1400 Ranch  
Plan

**New Construction**  
**Lot 49 Jasmine Rd.**  
**Fuquay Varina, NC**  
**Family Building Company**

**Job Number:**  
**2-3212-24**

**S1**

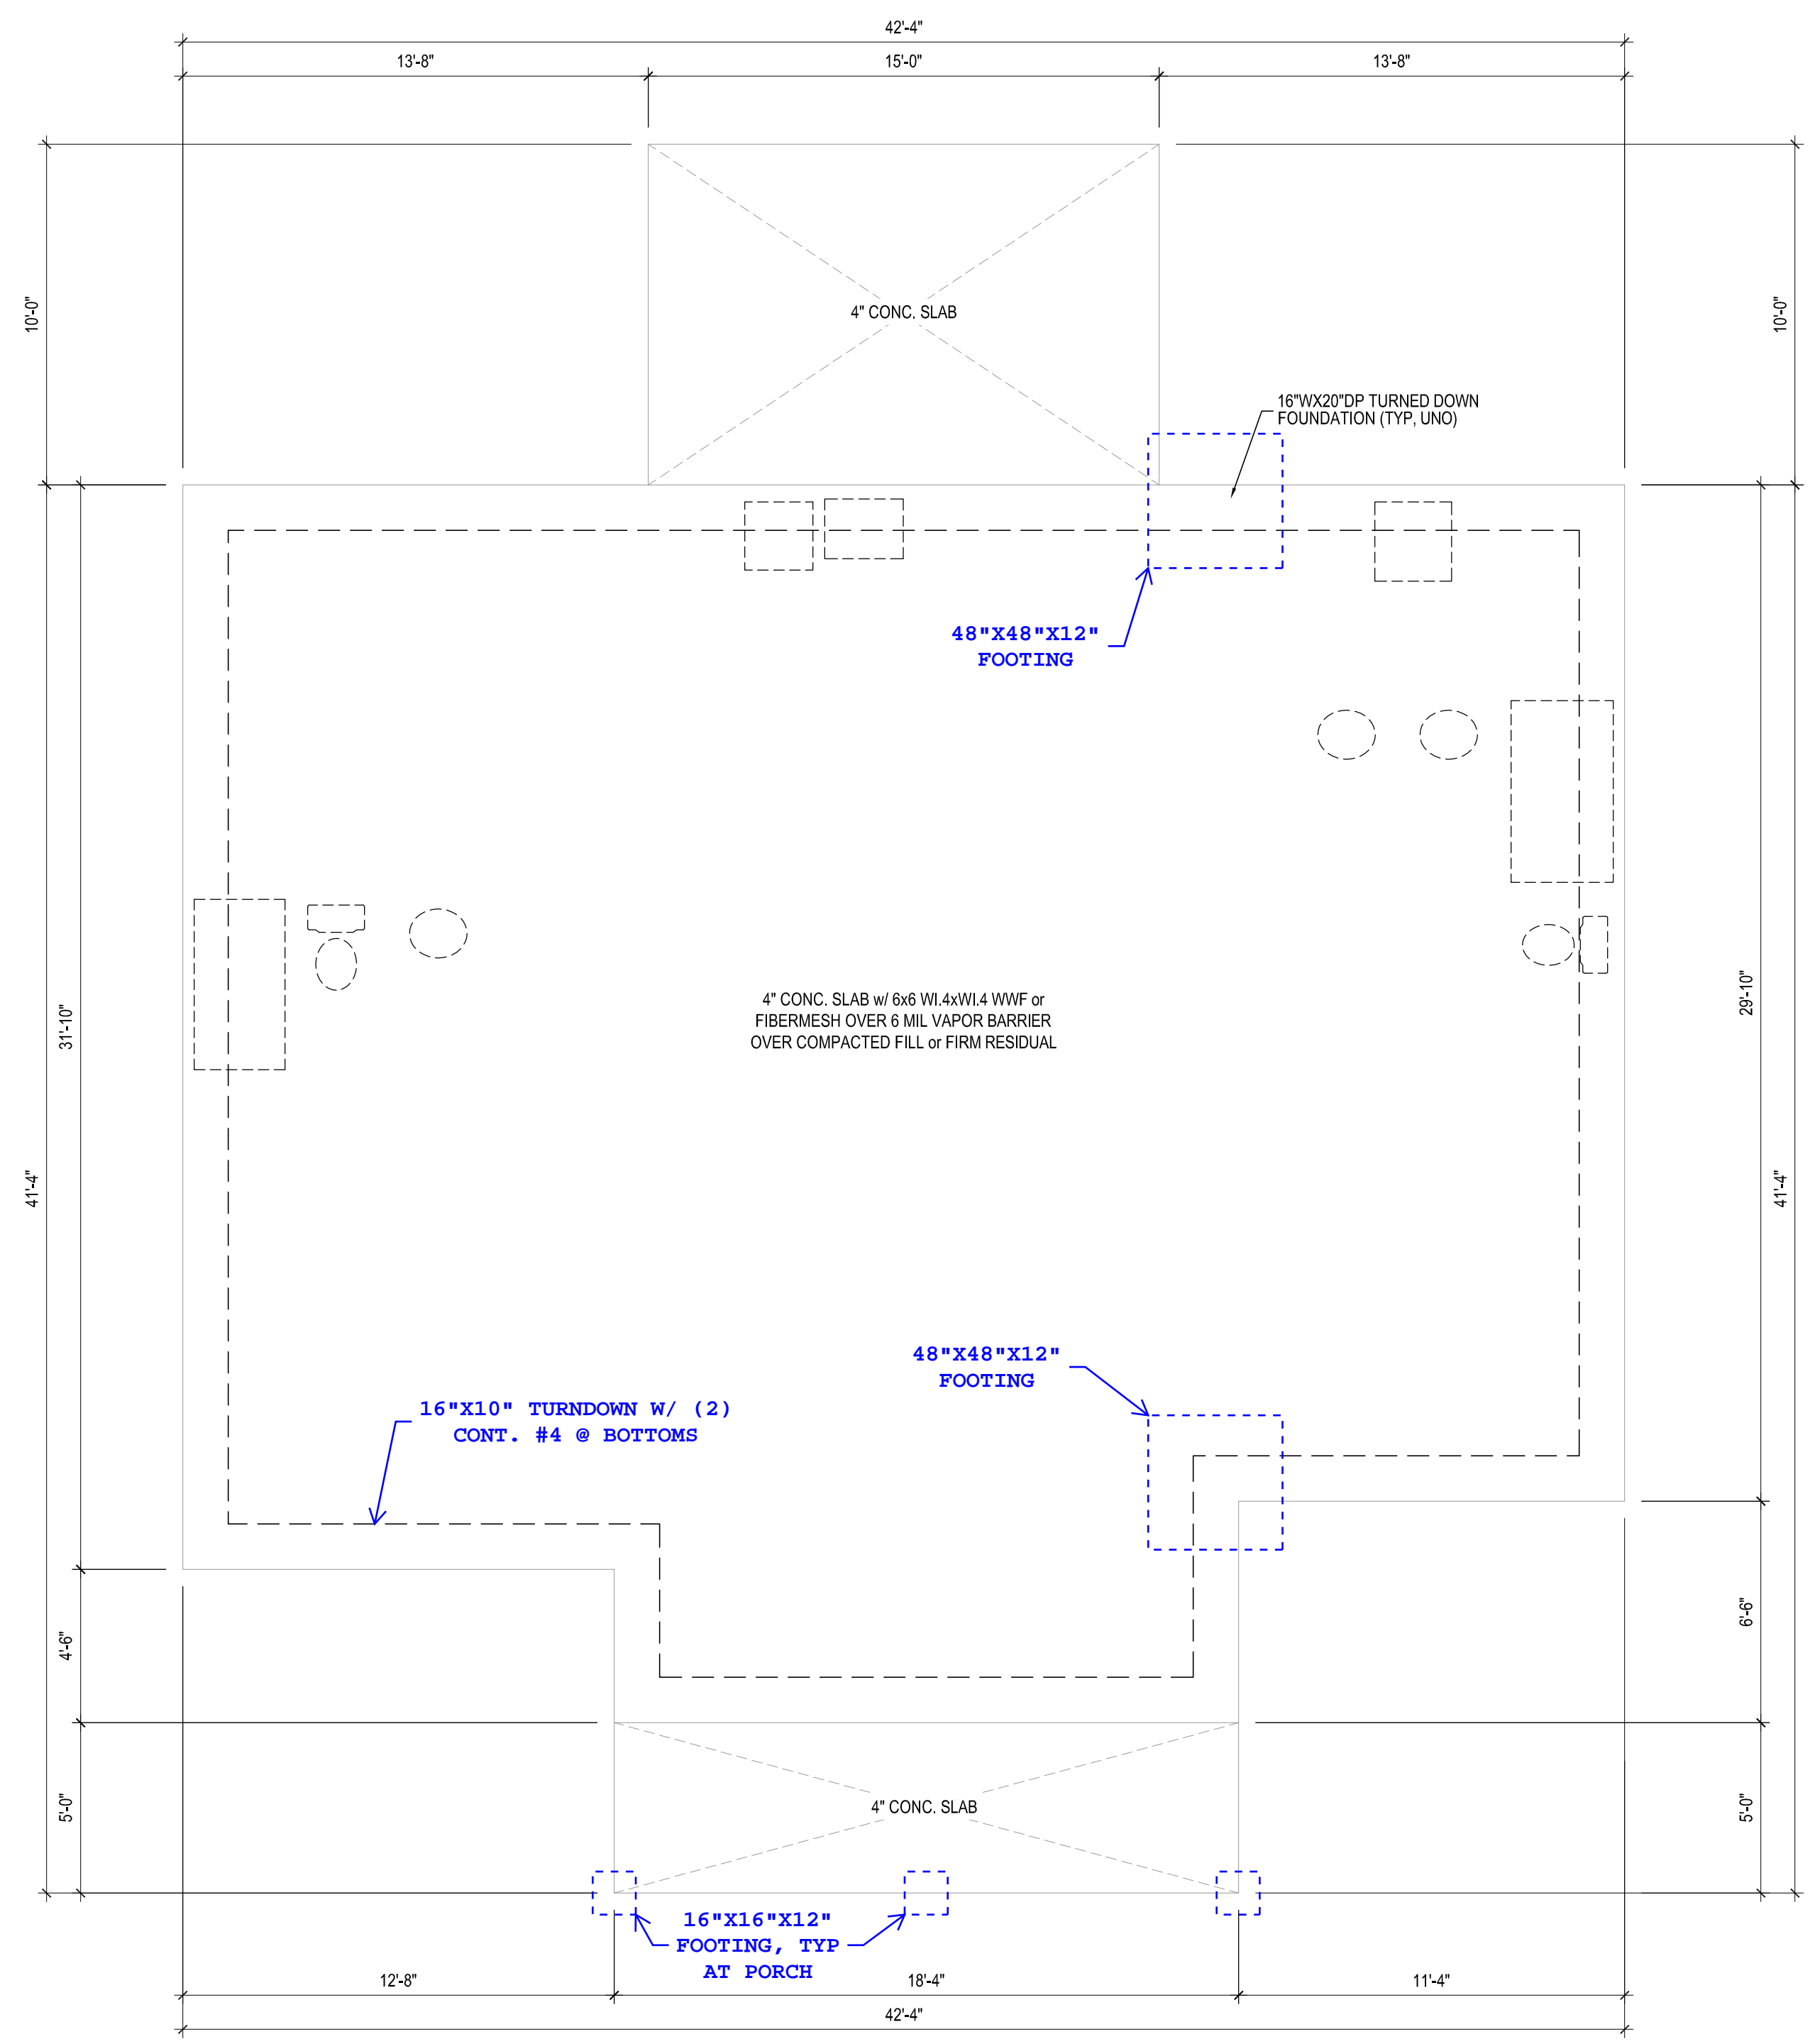
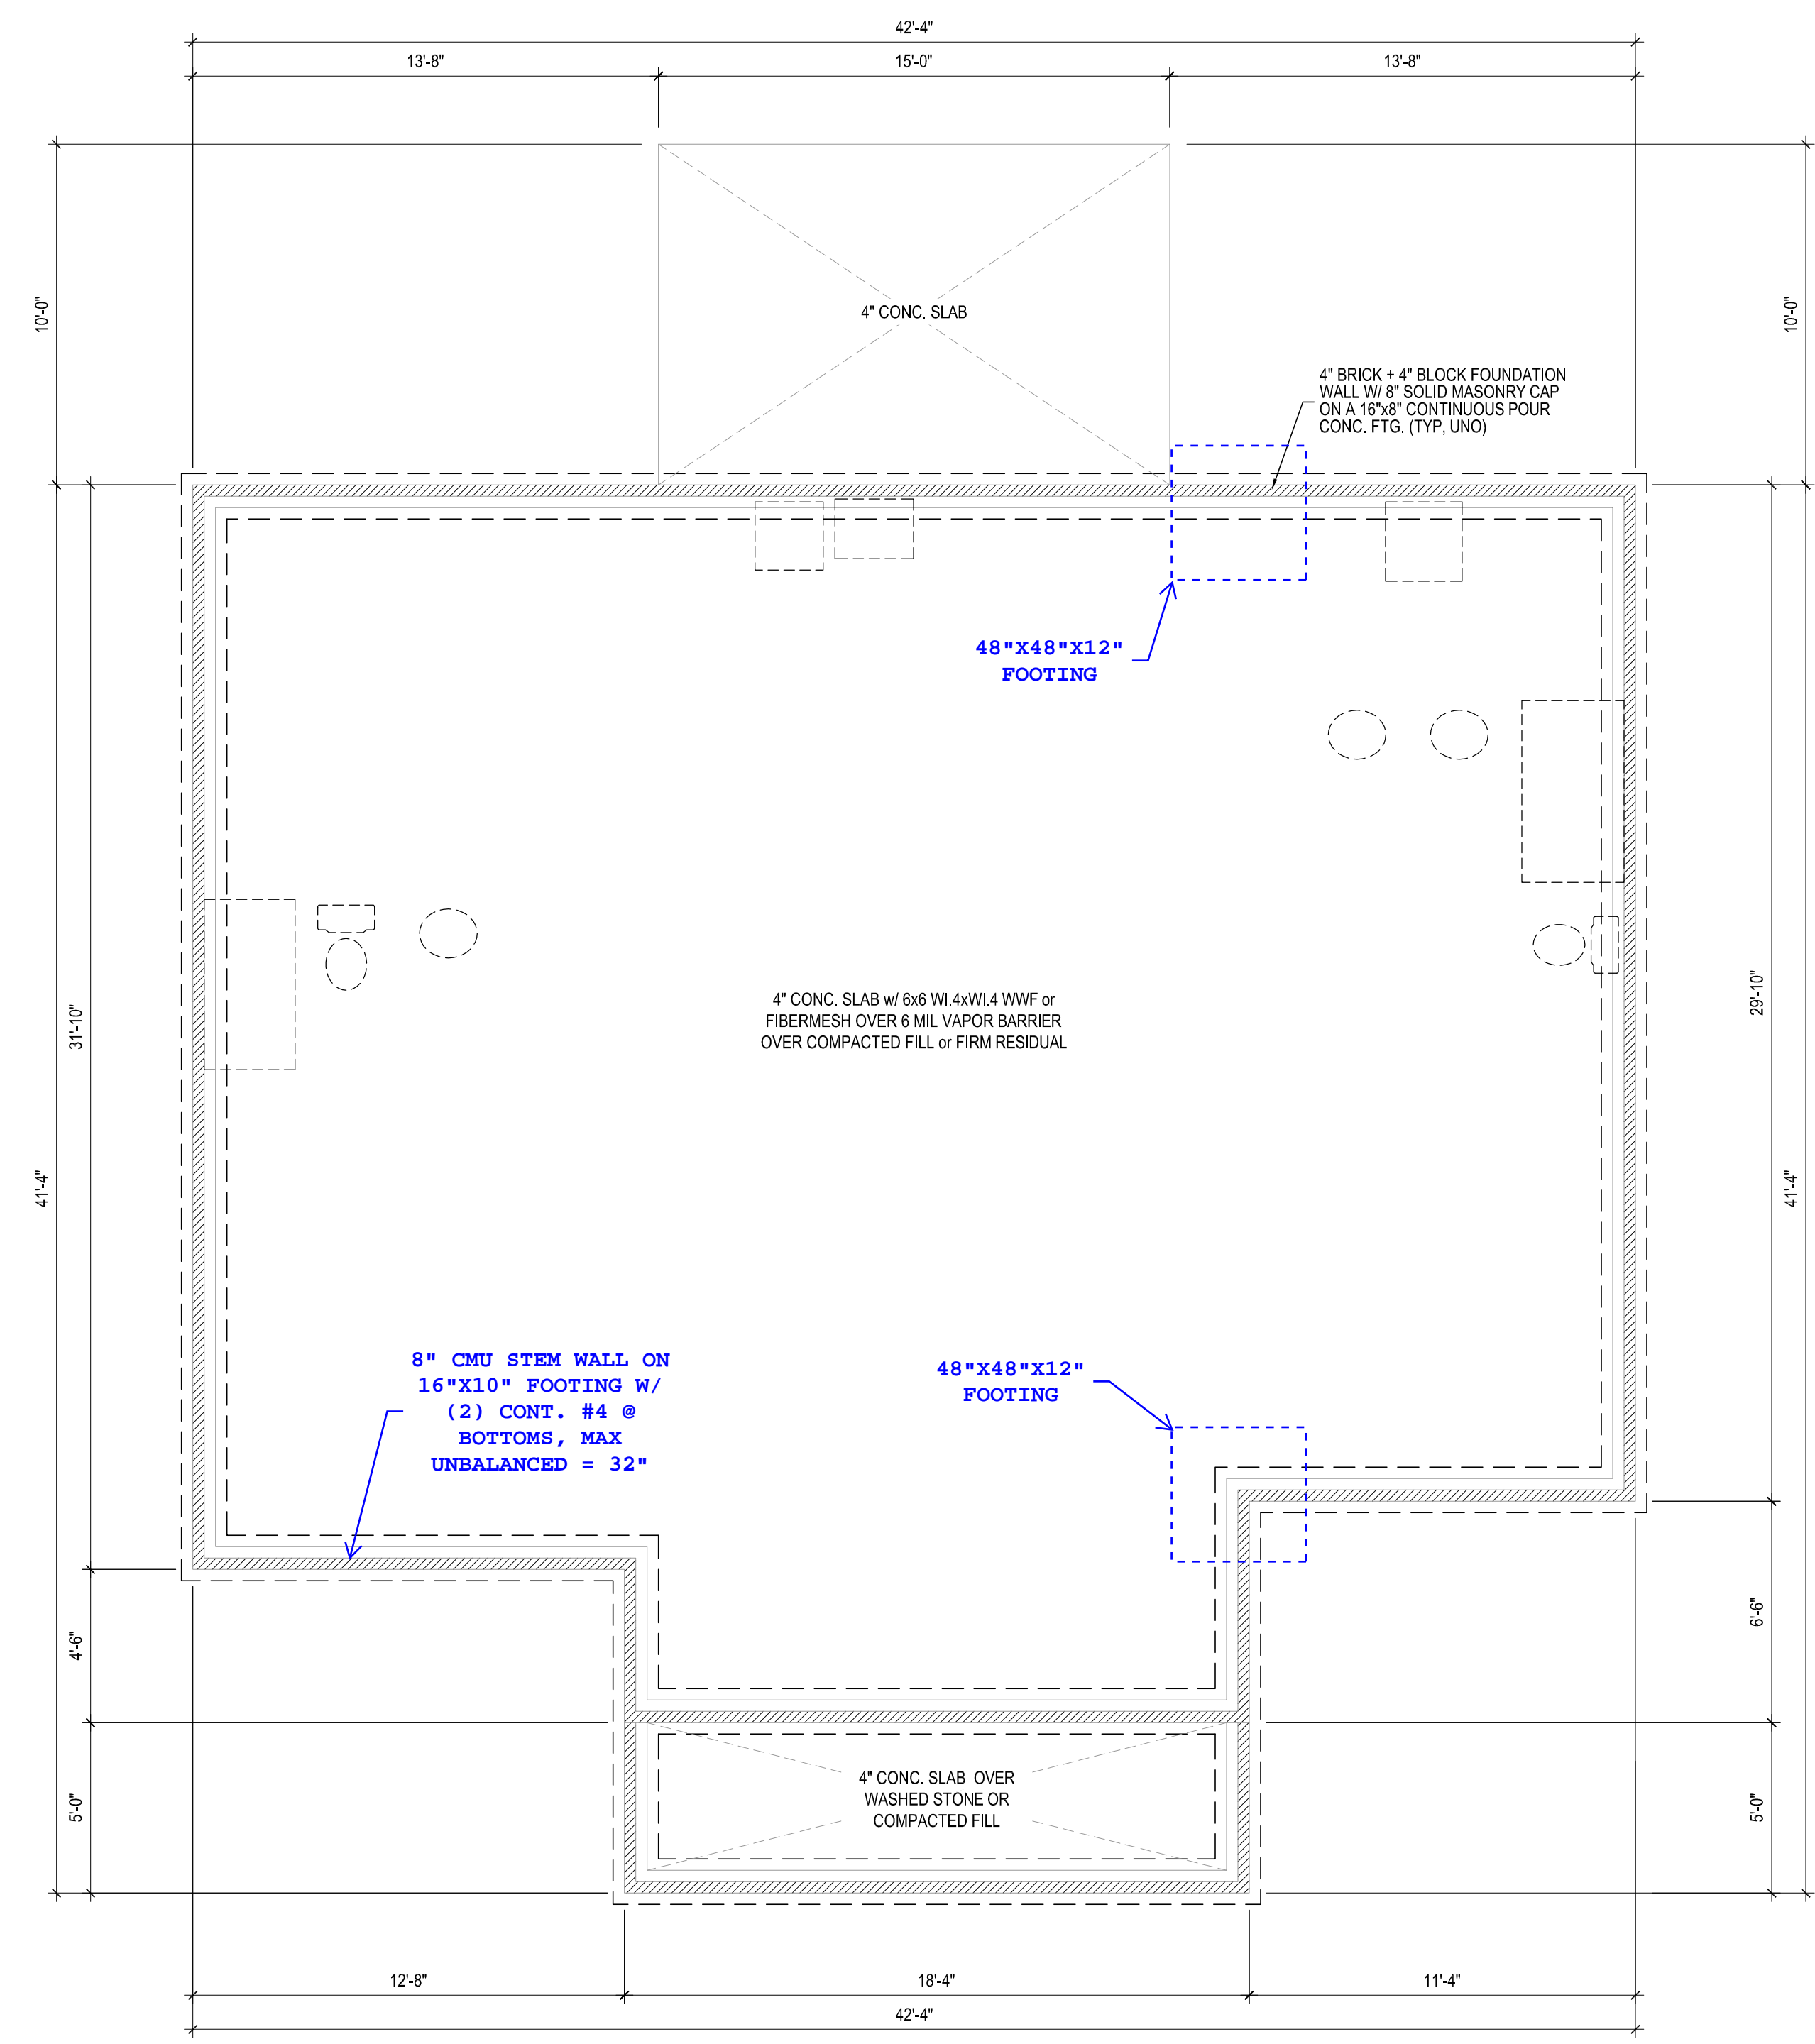
**FOUNDATION PLAN**  
 1/4" = 1'-0"  
**MONOSLAB OPT.**  
 \*ALL LUMBER TO BE #2 SYP, UNO

**FOUNDATION PLAN**  
 1/4" = 1'-0"  
**STEMWALL OPT.**  
 \*ALL LUMBER TO BE #2 SYP, UNO
